Meeting Notes - Erosion Control/Stream Alteration Site Visit – Richmond VT

Re: Fluvial Geomorphic Context of the Winooski River in Richmond, VT

Subject: Richmond's Winooski bank stabilization quandary

**U.S. ARMY CORPS OF ENGINEERS
APPLICATION FOR DEPARTMENT OF THE ARMY PERMIT**
33 CFR 325. The proponent agency is CECW-CO-R.

A drafty, draft sketch of proposed riverbank/floodplain enhancements

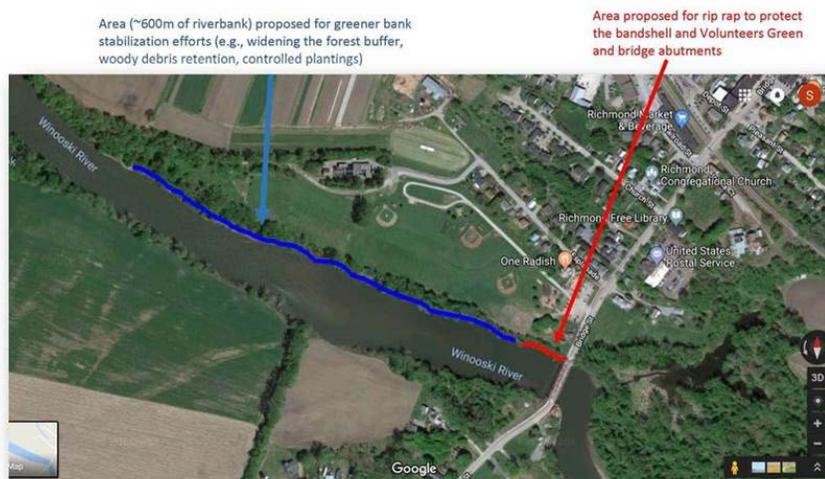
I live in Richmond and have been talking with the Selectboard and town manager about a plan to rip rap a ~240' stretch of the north bank at the Bridge St. bridge (see the red line in the photo below). The bridge lacks a downstream wing wall and the river has hammered the bank here cutting the 'forest' buffer to just about one tree-width. Chris Brunelle visited the site last year and essentially said that rip rap was the only option for protecting the infrastructure here.

I'm organizing support for a companion project to the rip rap focused on the 600m of rivershore immediately downstream (the area marked in blue) to widen the forest buffer and to also do greener bank stabilization and perhaps even in-river enhancements. The town has a conservation fund that can cover at least some of the costs. On Monday I walked the area with Katie Kain and Will Eldridge to talk about planting trees and I expect that we will work together on that part of the project.

1. Does rip rapping the bank immediately downstream of the bridge cause significant worry for you with regard to the redds identified a bit further downstream?
2. Would you be interested in seeing greener bank stabilization, in-stream enhancements (i.e., wood) or something else that would benefit salmon done just downstream of the rip rap area? Do you know if it'd be feasible? Katie, Will, Chris and Gretchen Alexander have all said that they didn't have experience doing such things on a river the size of the Winooski. I believe them, but I also want to keep asking as this would be a good opportunity to get such work approved.

My quick answer is:

1. I'm not worried about the rip rap.
2. I too, have no experience with river restoration – especially a river this size. Need to bring the big guns in for this one.
3. My big concern would be that many of the salmon redds found in the area can be located tight up against the bank. For whatever reason, the flow, depth and substrate along the edges are what these fish like.

I think the expanded buffer sounds great. In stream work I'm not sure and would need some discussion.
